Exhibit 1
First Amendment to
Consent Decree Re: Whatcom
Waterway Site, Bellingham, WA

First Amendment to EXHIBIT B
Cleanup Action Plan

Figure 6-5 Whatcom Waterway Cleanup Action – First Amendment

Figure 6-5
Whatcom Waterway Cleanup Action - First Amendment

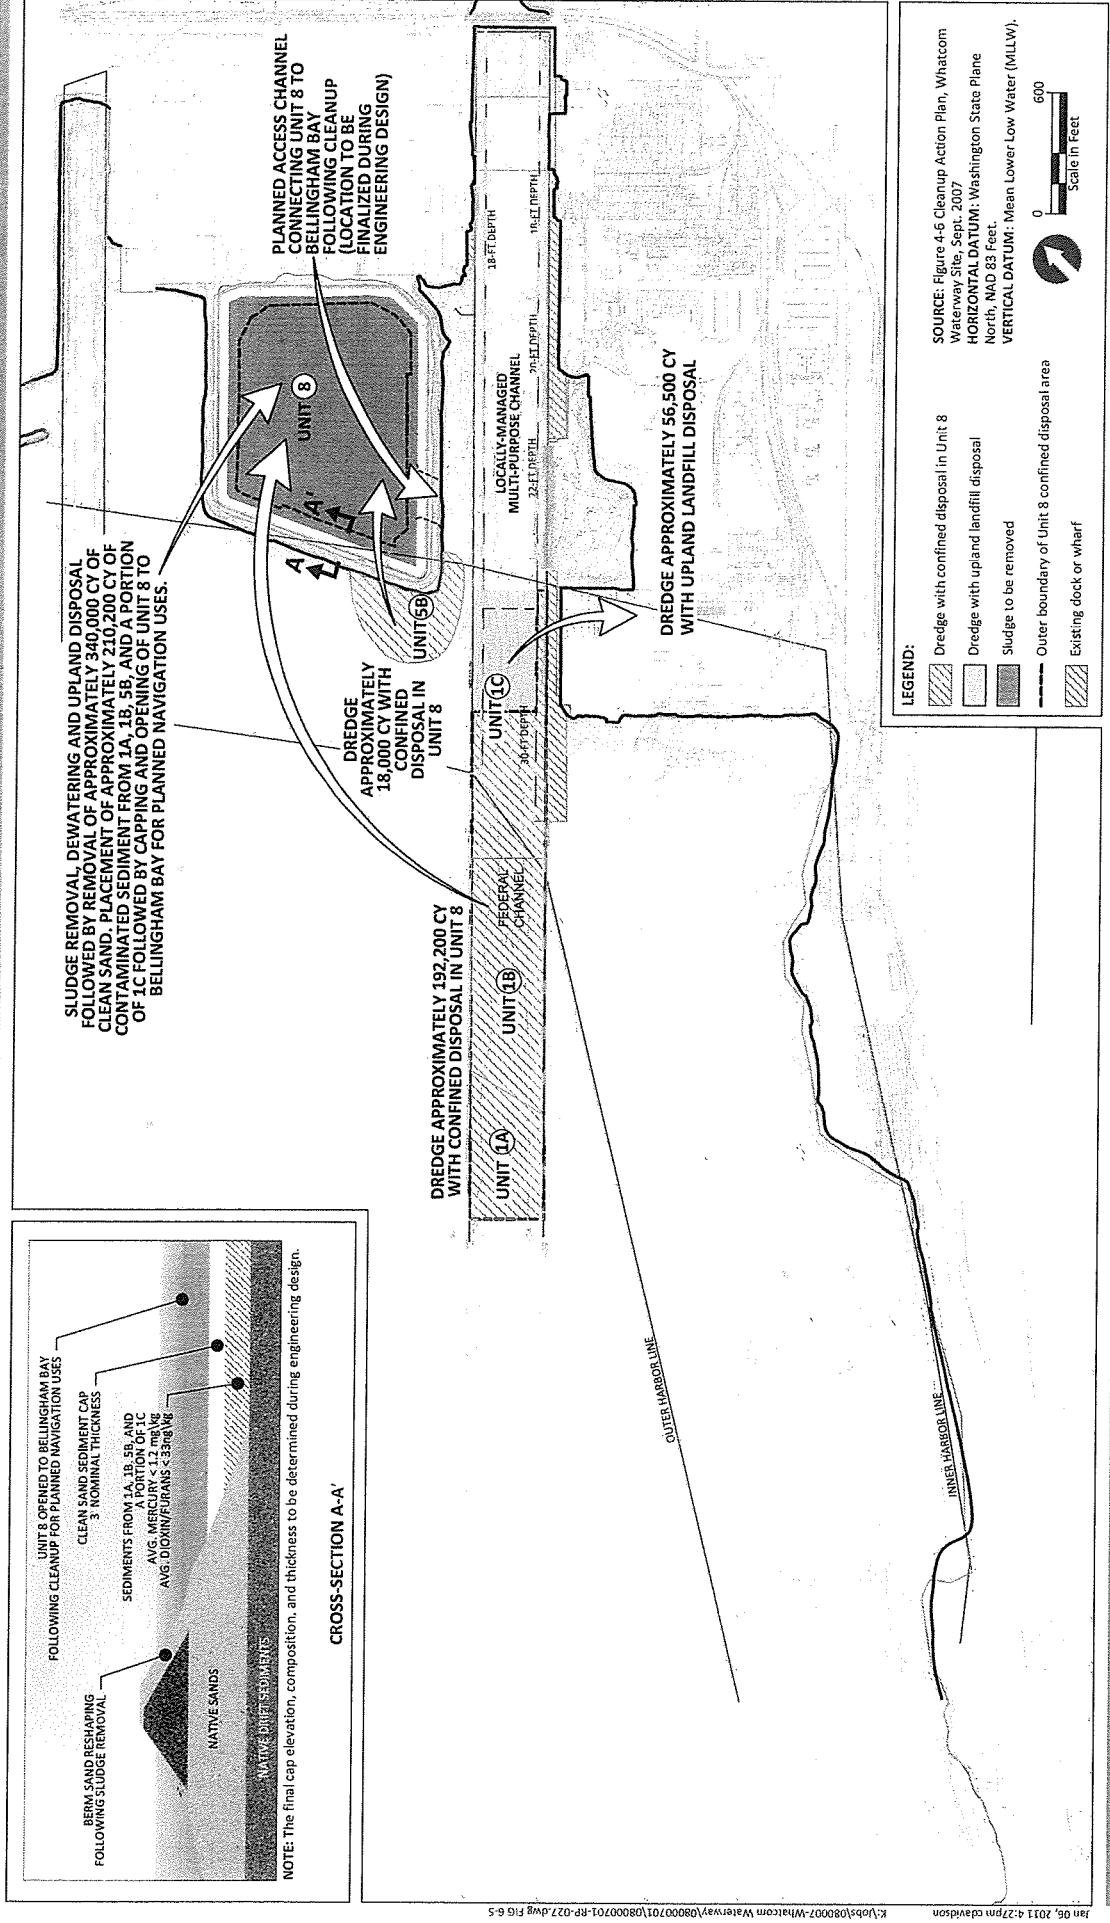
Under a First Amendment to the Cleanup Action Plan Re: Whatcom Waterway Site (First Amendment to the CAP), adjustments were made to the original cleanup action selected for these specific areas of the Site (Figure 6-5). The CAP now requires the Port to do the following:

Pursuant to the First Amendment to the CAP, Figure 6-5 illustrates the elements of the cleanup action for Units 1A and 1B, a portion of 1C, 5B, and 8. Technologies used as part of the cleanup include removal with Subtitle D disposal, treatment, containment, and institutional controls.

Seventh, the placement area will be covered by a layer of clean sediment, or cap, to provide for long-term containment of the placed sediments (see Figure 6-5). The cap will have a nominal thickness of at least 3 feet and is expected to consist of sandy sediments. The target elevation of the top of the cap is estimated to be -14 feet MLLW or deeper, consistent with planned navigation uses of Unit 8. The final cap elevation, composition, and thickness will be determined during engineering design.

Figure 6-5 depicts the Unit 8 confined disposal area and the average contaminant concentrations of the sediments (Units 1A, 1B, 5B, and part of 1C) placed and capped within Unit 8.

Figure 7-2. Implementation Schedule - First Amendment to Cleanup Action Plan ^{[1][4]}

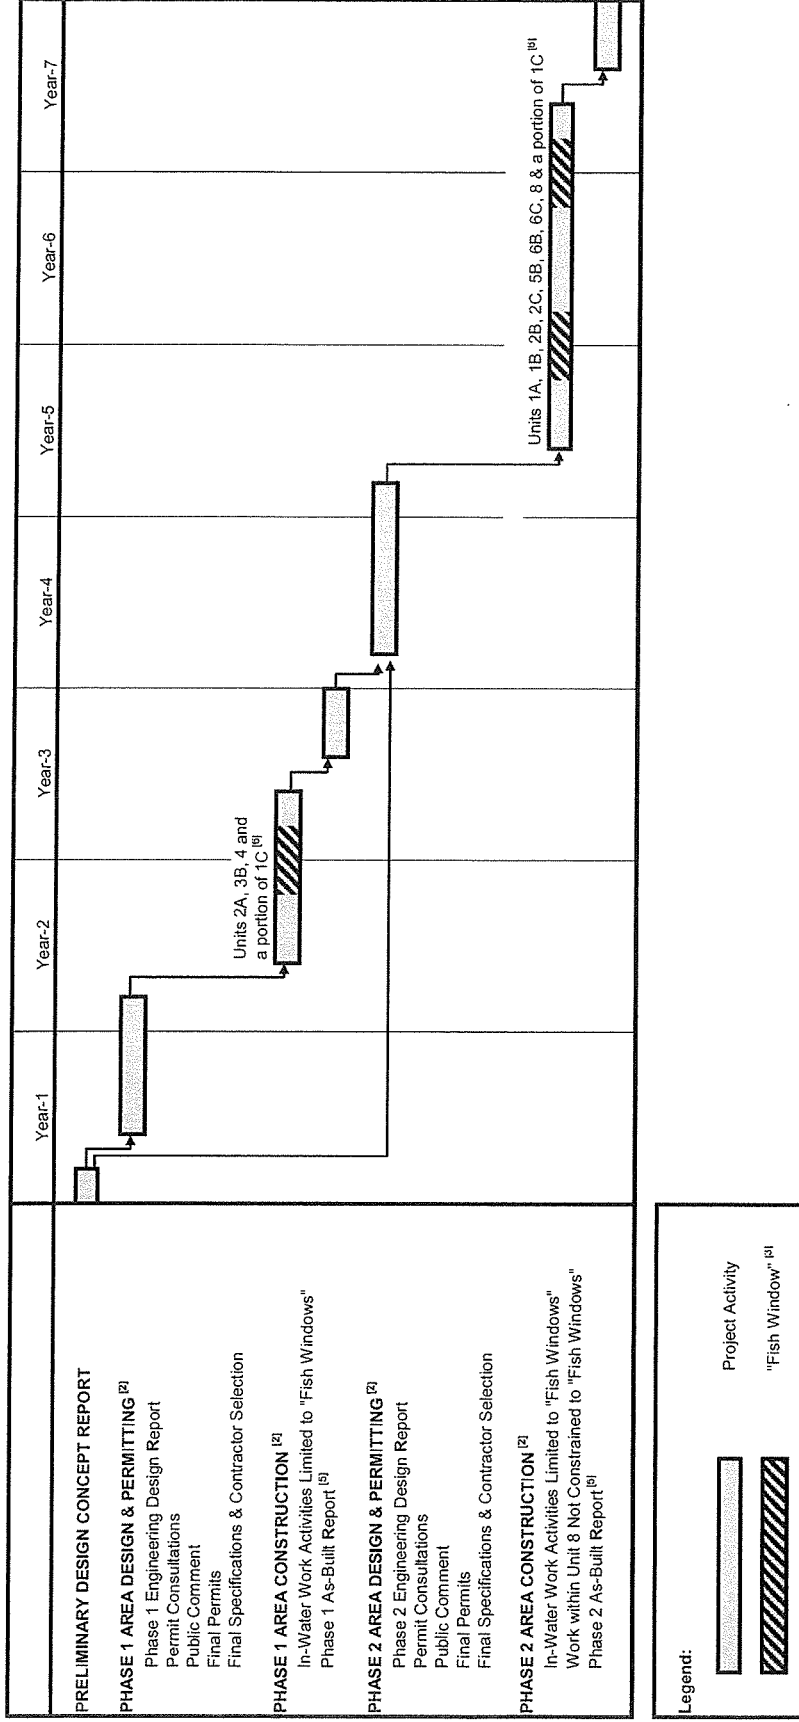
[And, Figure 7-2 is replaced with the following:]

The project schedule was also adjusted to reflect the implementation of the work as two construction actions or phases, each under its respective permits. This provides for expedited cleanup of the inner waterway, the Log Pond, and portions of the Site that are independent of Unit 8. This work also accommodates early redevelopment actions. The adjusted project schedule is attached to the Decree as Exhibit C, and is shown in Figure 7-2.

The schedule for design and implementation of the Whatcom Waterway cleanup is attached to the Decree as Exhibit C and is illustrated in Figure 7-2. The considerations for the schedule selected are described below;
